**DOCUMENT 00 90 00  
ADDENDUM**

**ADDENDUM NO. [1]                      Date: March 13, 2020**

**RE:                      SCHOOL DISTRICT OF HOLMEN  
                             HIGH SCHOOL ADDITION AND REMODELING PHASE 2  
                             1001 McHUGH ROAD  
                             HOLMEN, WISCONSIN 54636  
                             HSR 18061**

**M103**

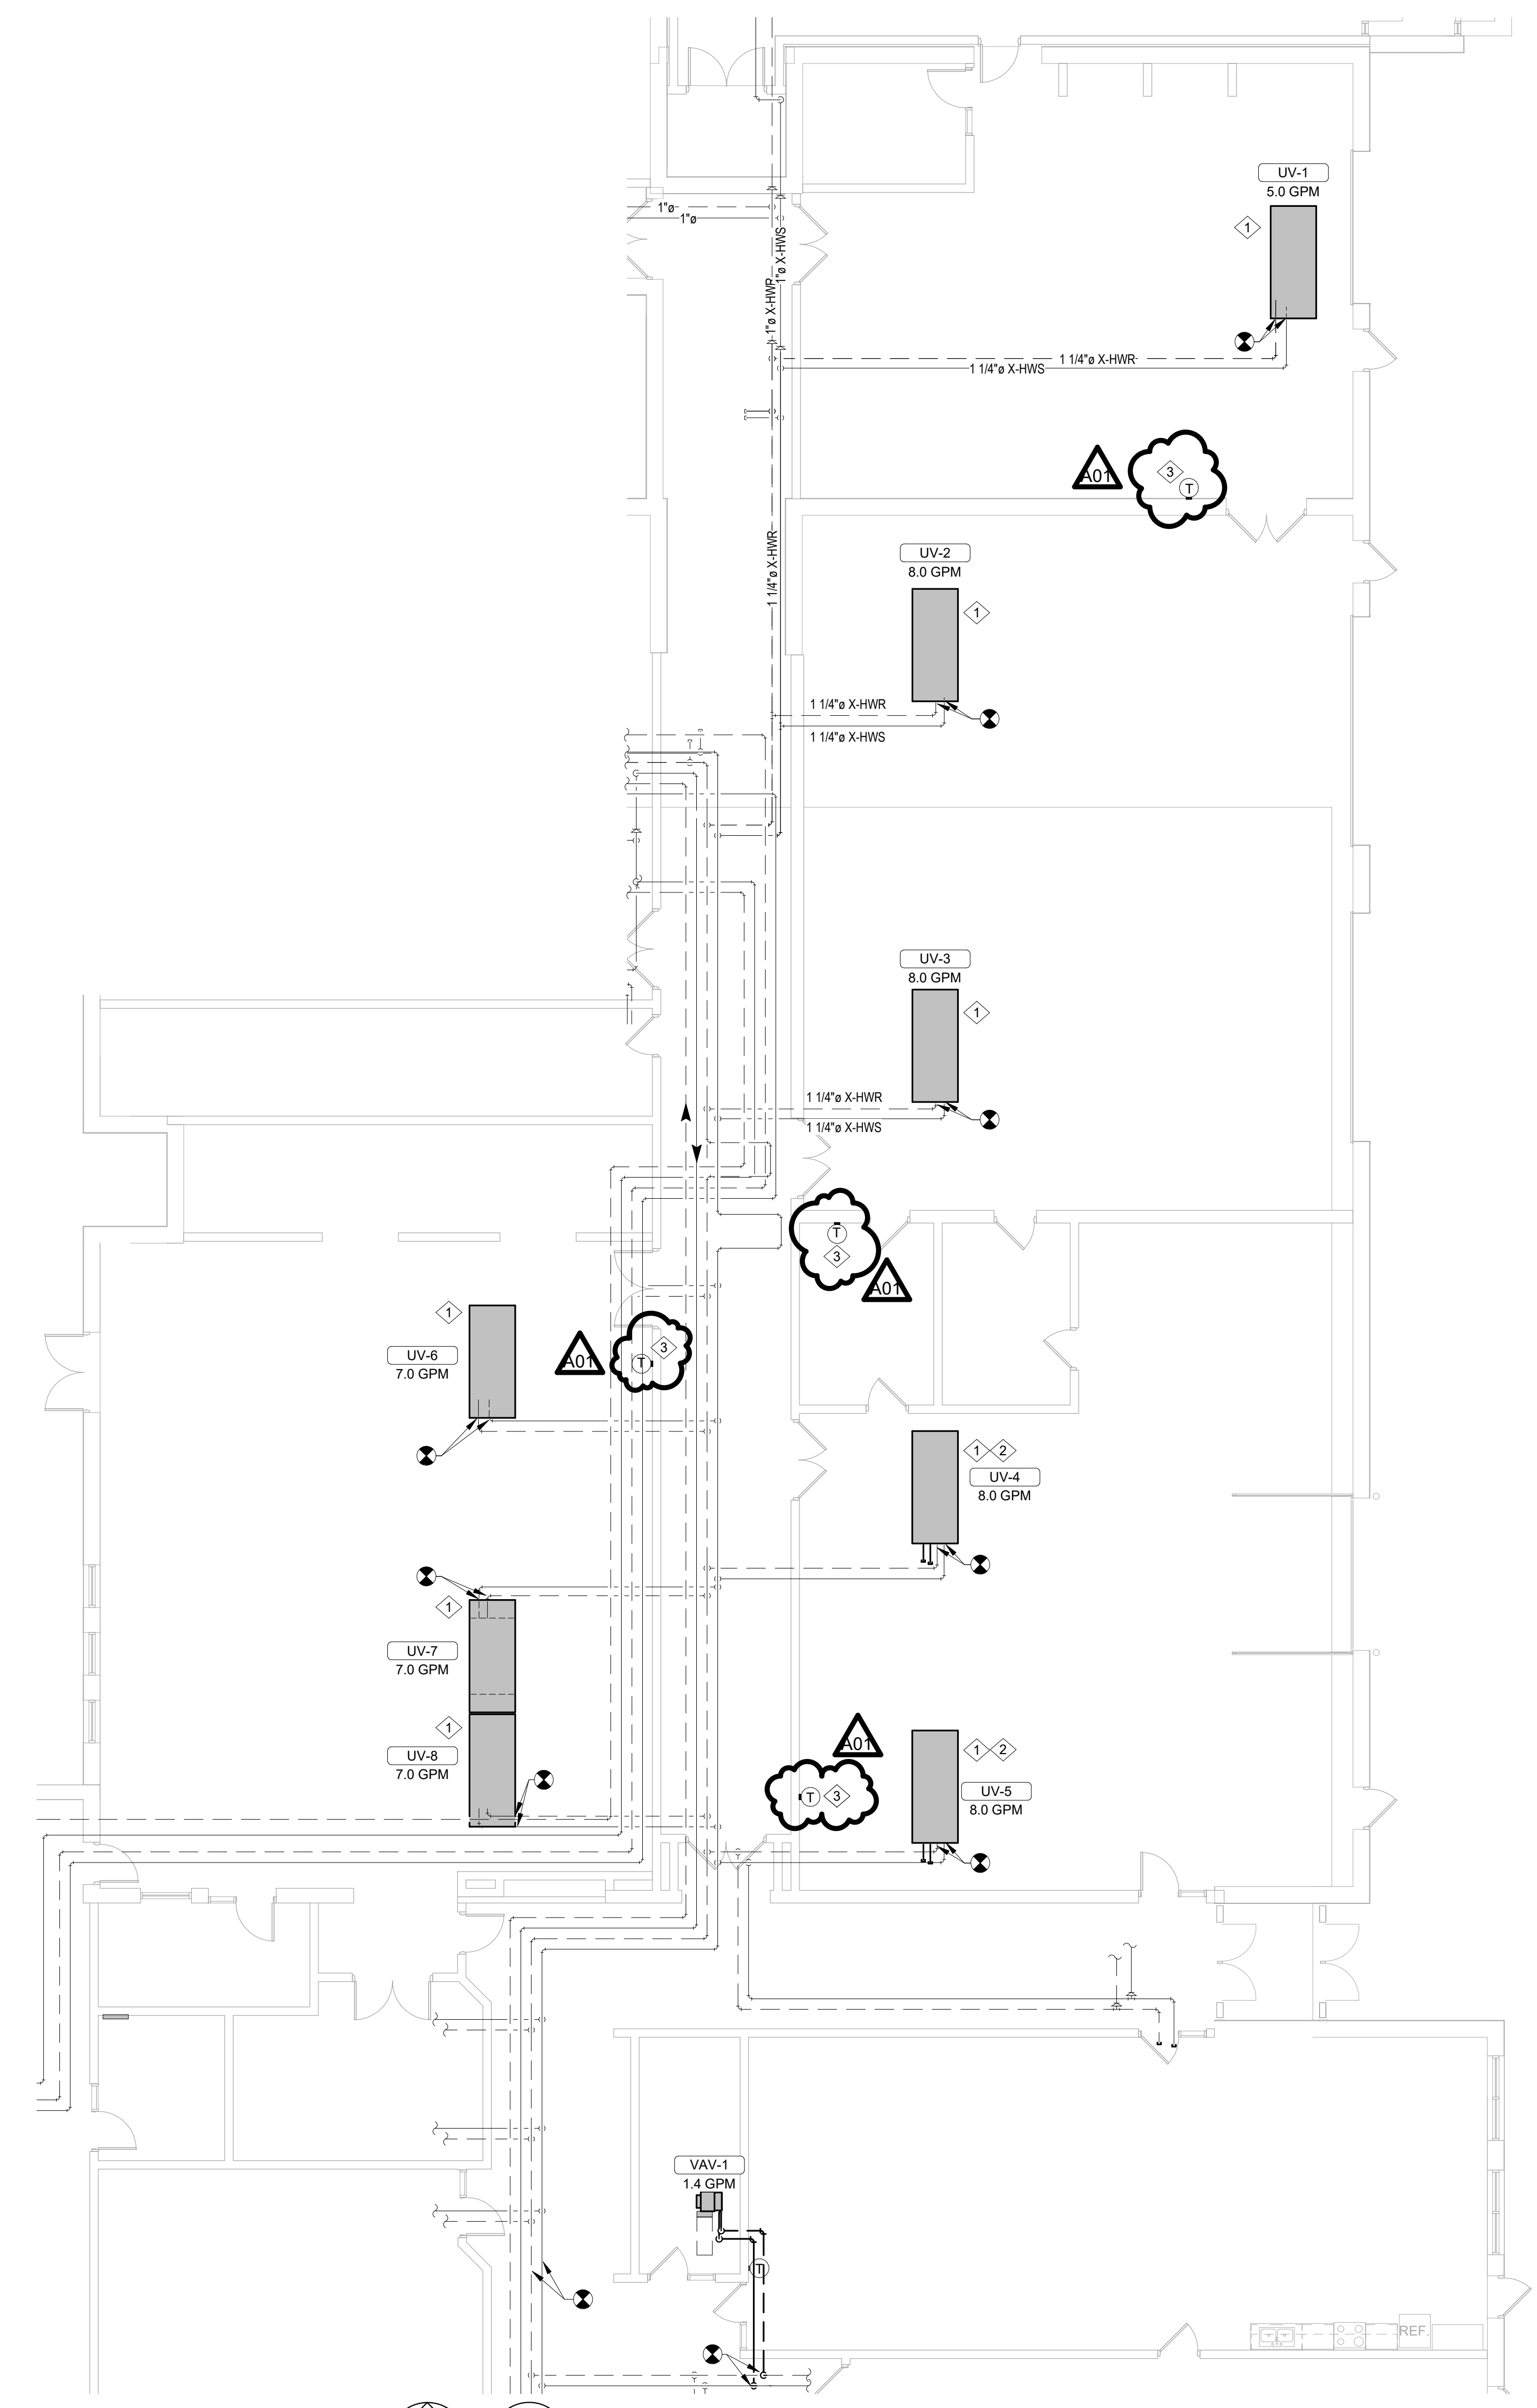
30. Sheet M105 MECHANICAL PIPING REMODEL PLAN – SEGMENT E 30 x 42 attached hereto.
  - a. Revisions clouded on Drawing.
  - b. New thermostats to be installed with the upgraded DDC Controls for new Unit Ventilators.

**M105**

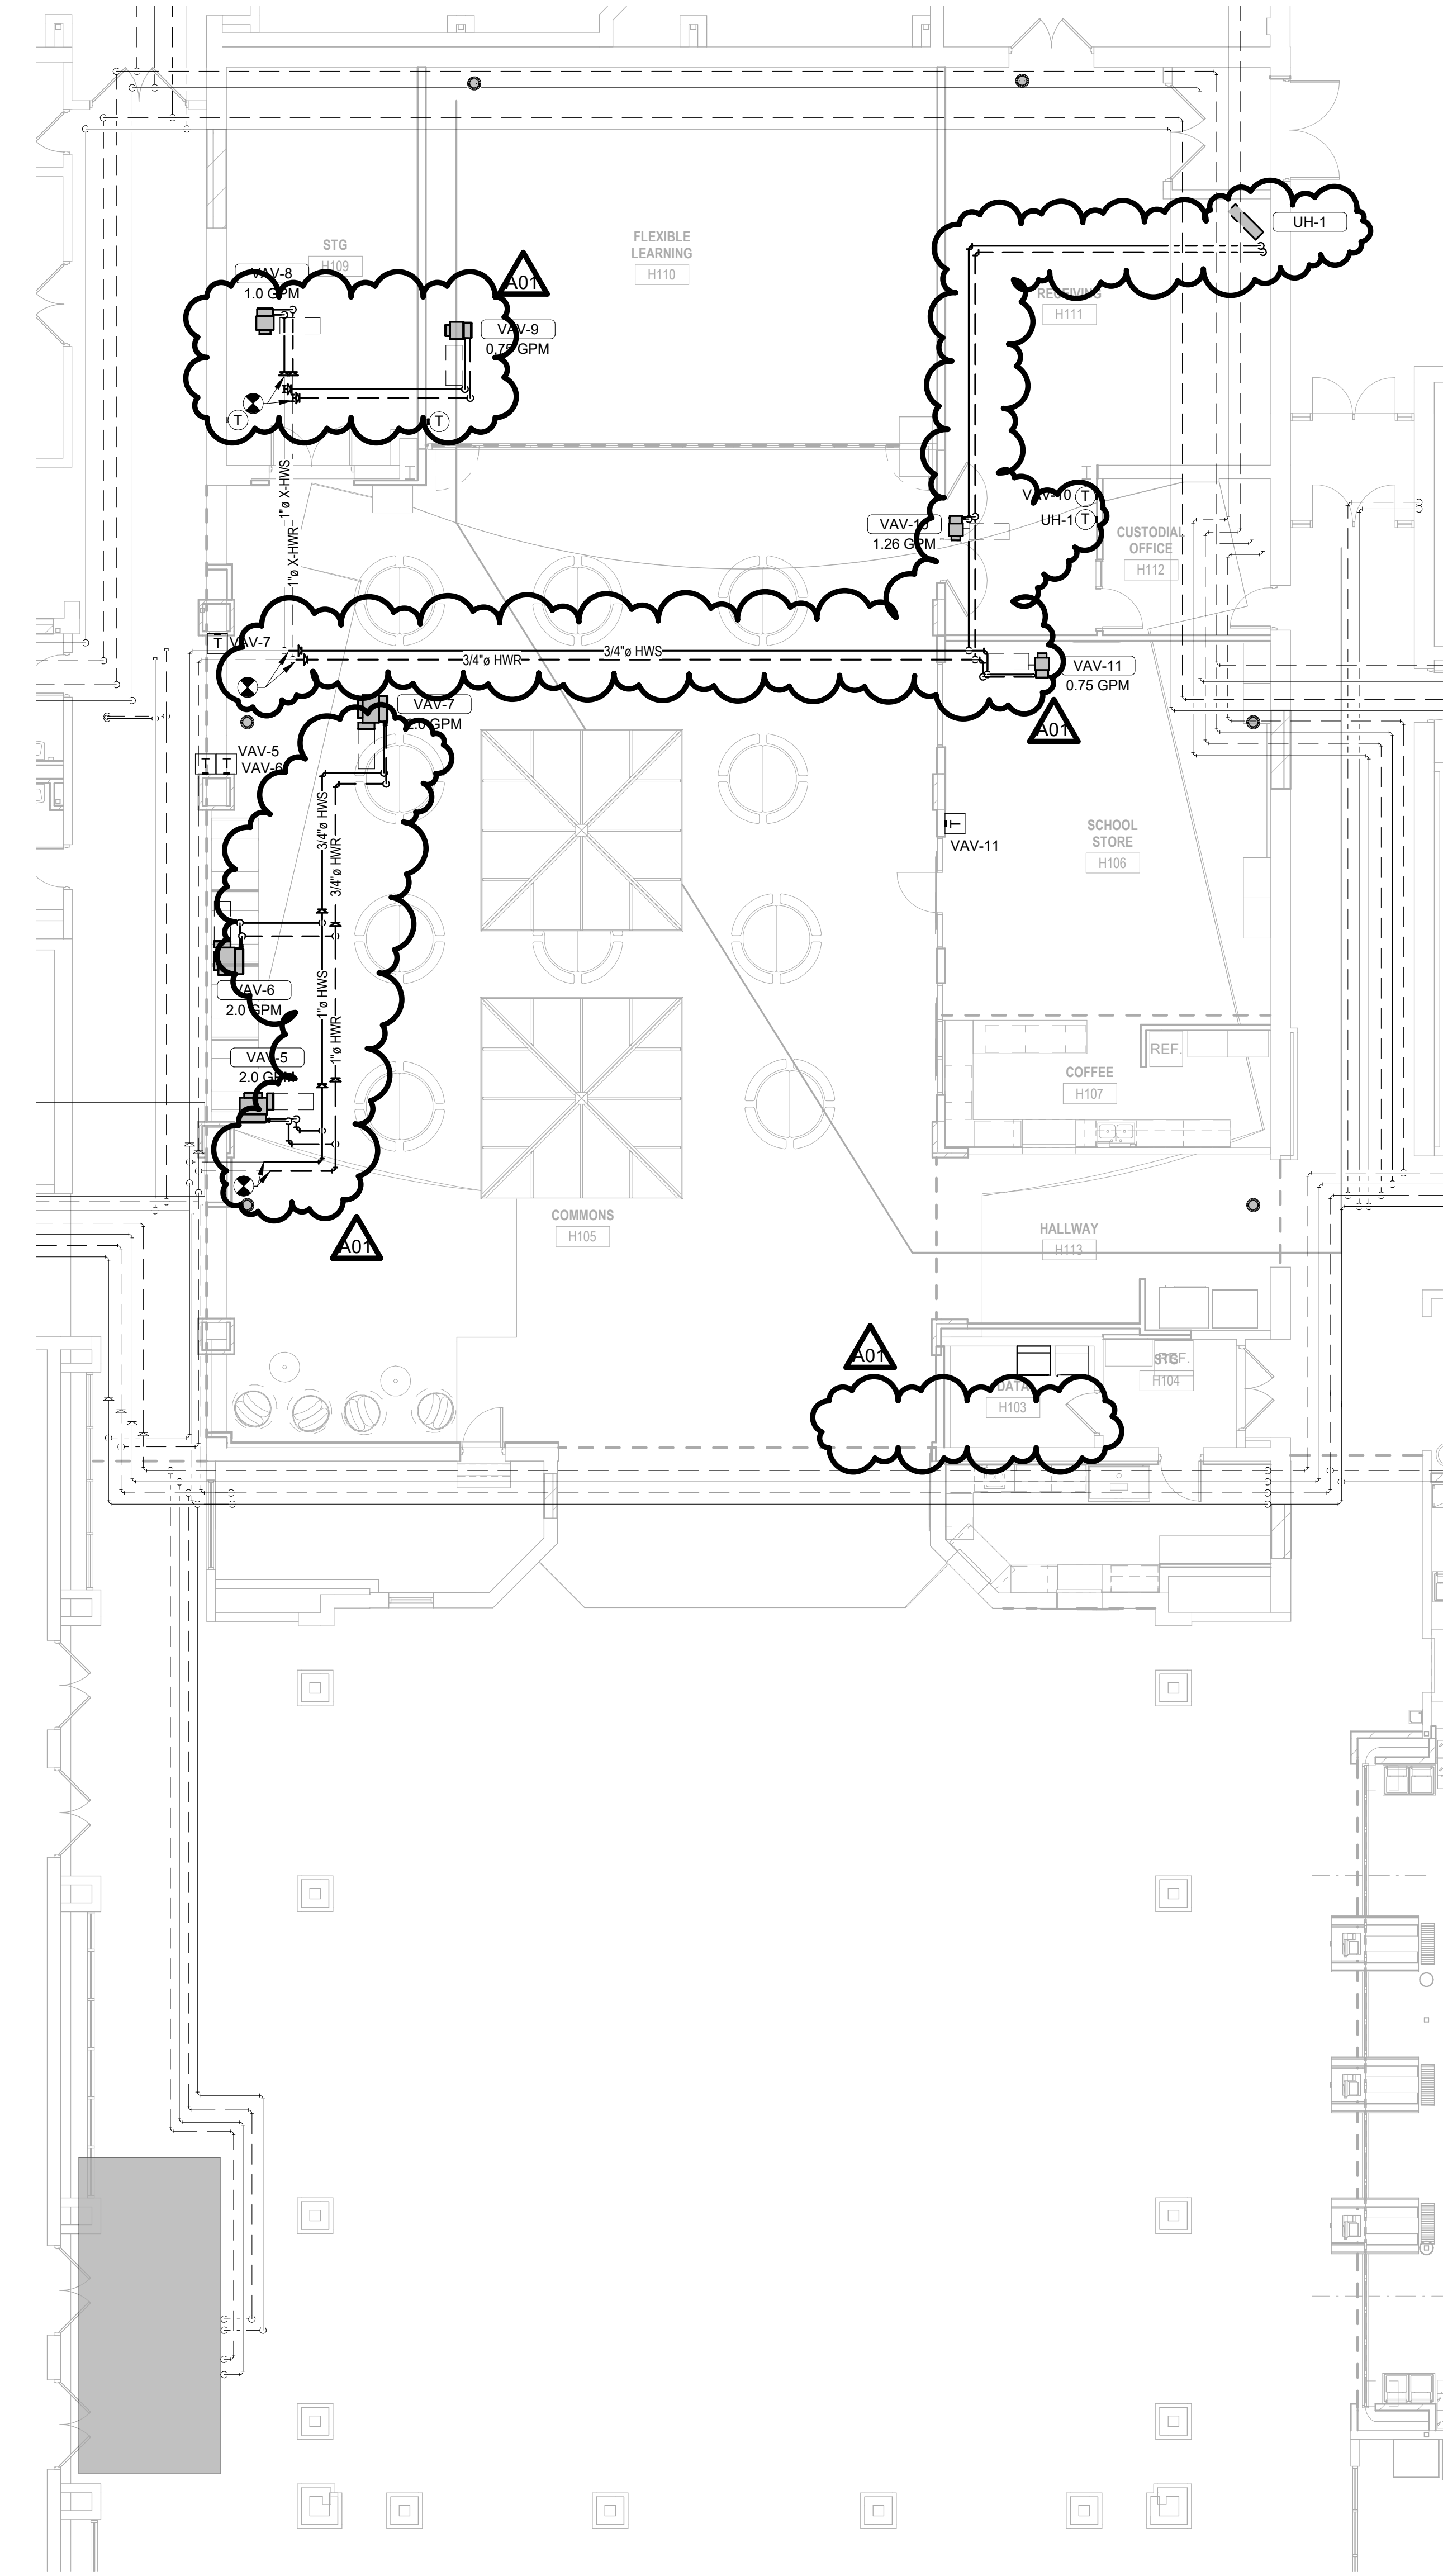
31. Sheet M107 MECHANICAL PIPING REMODEL PLAN – SEGMENT H 30 x 42 attached hereto.
  - a. Revisions clouded on Drawing.
  - b. New piping connections have been shown to the new VAV boxes and Unit Heater. New Stand-alone T-stat for new UH-1.

- c. The mini-split unit is no longer required by IT. Unit has been removed along with the condensate piping.
32. Sheet M108 MECHANICAL ROOF PLAN 30 x 42 attached hereto.

**1 MECHANICAL DUCTWORK MEZZANINE ROOM**  
1/8" = 1'-0"

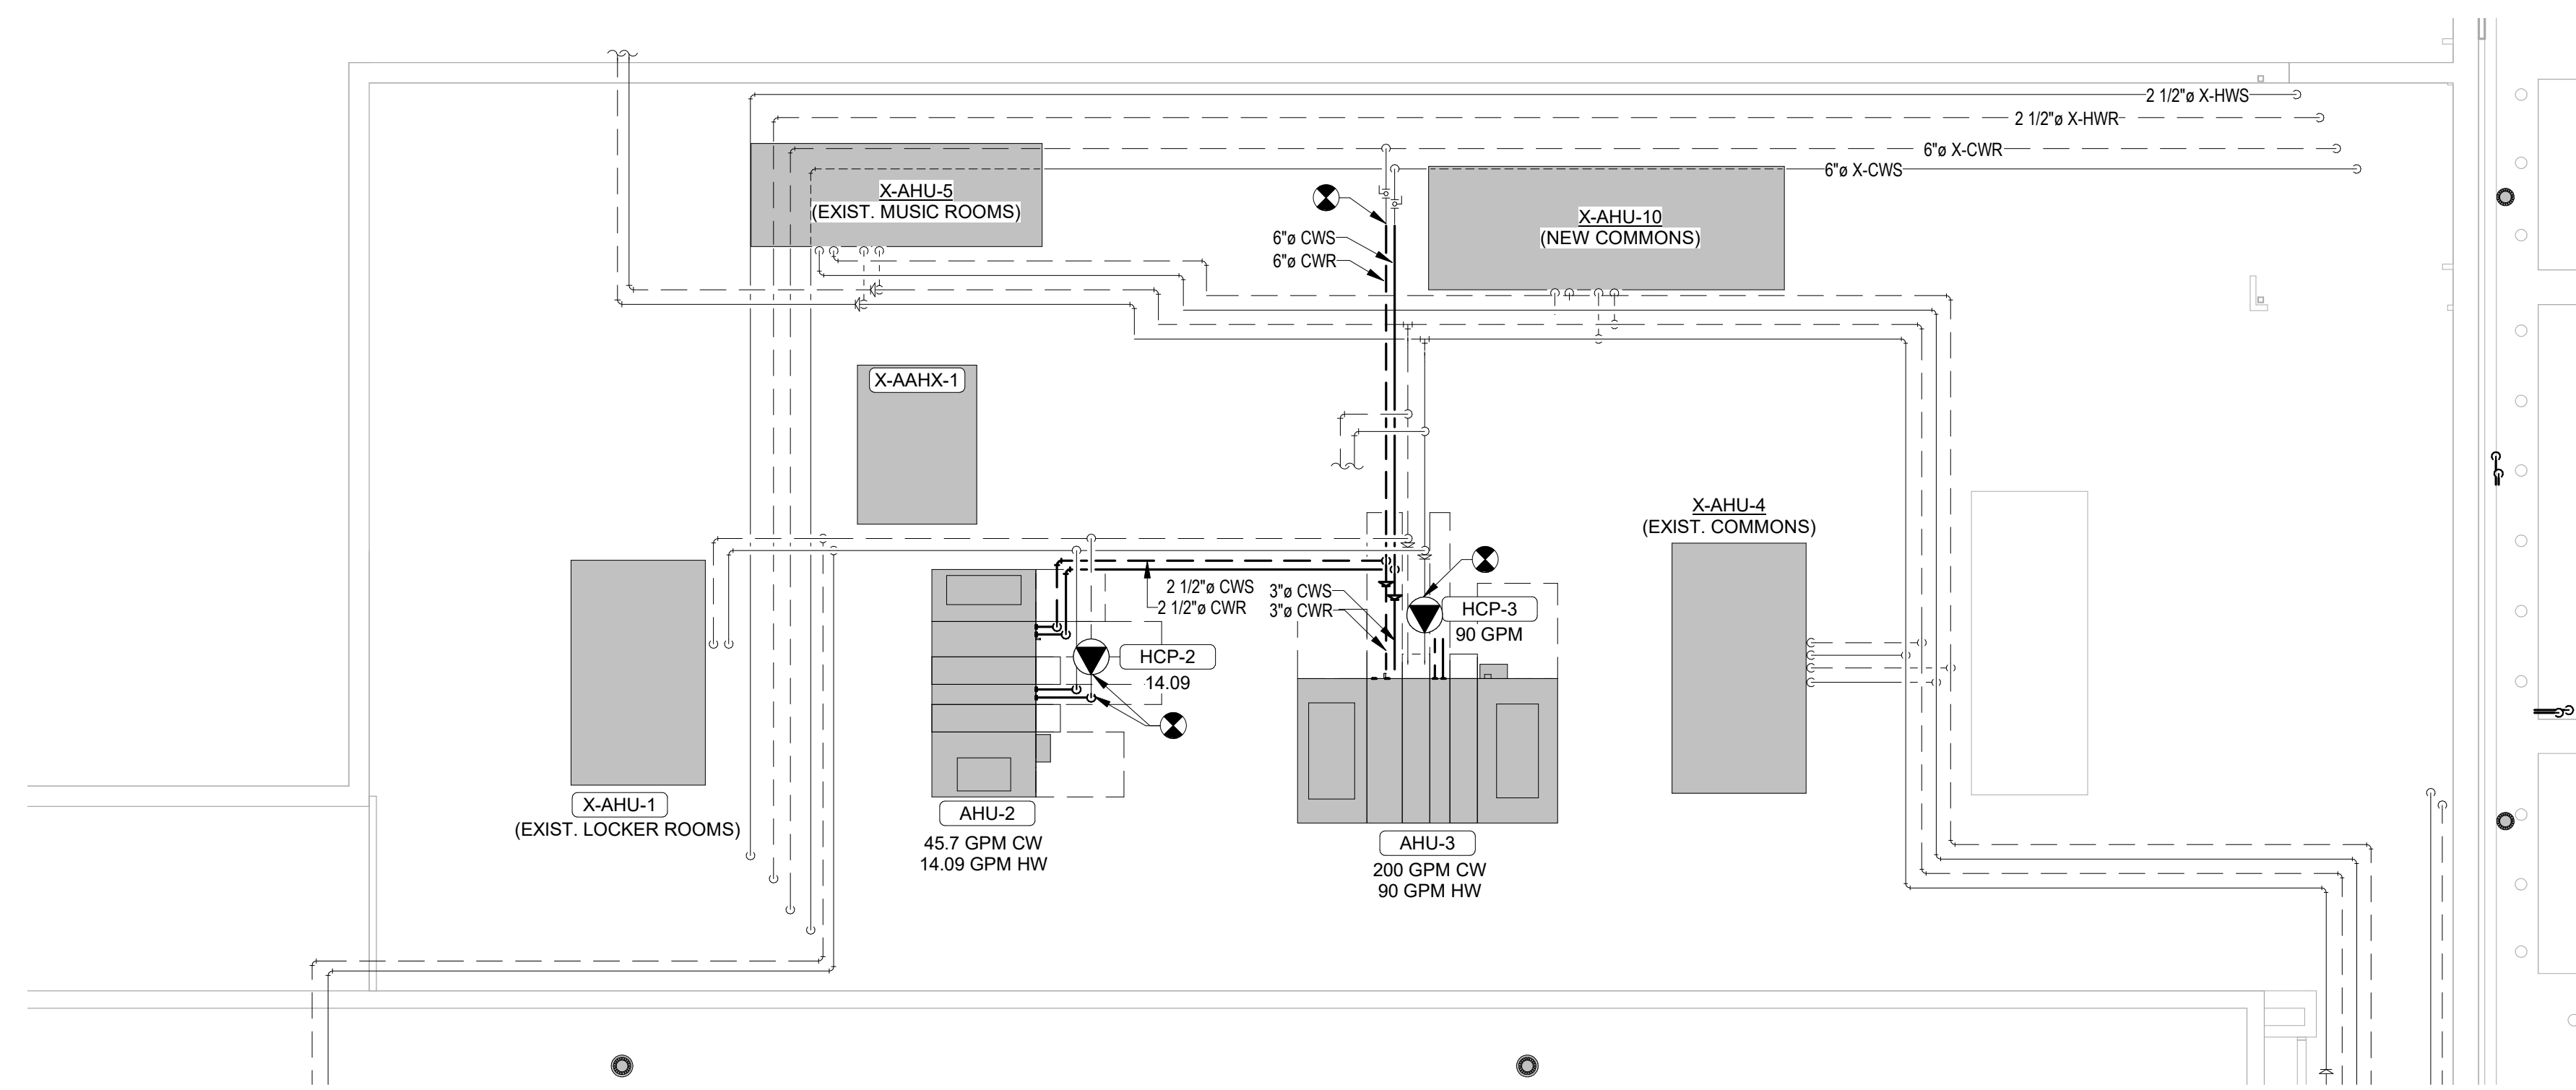
- a. Revisions clouded on Drawing.
  - b. New AHUs (AHU-2 and AHU-3) have been shown along with new recirculating Pumps (HCP-2 and HCP-3).
34. Sheet M400 CONTROL SCHEMATICS 30 x 42 attached hereto.
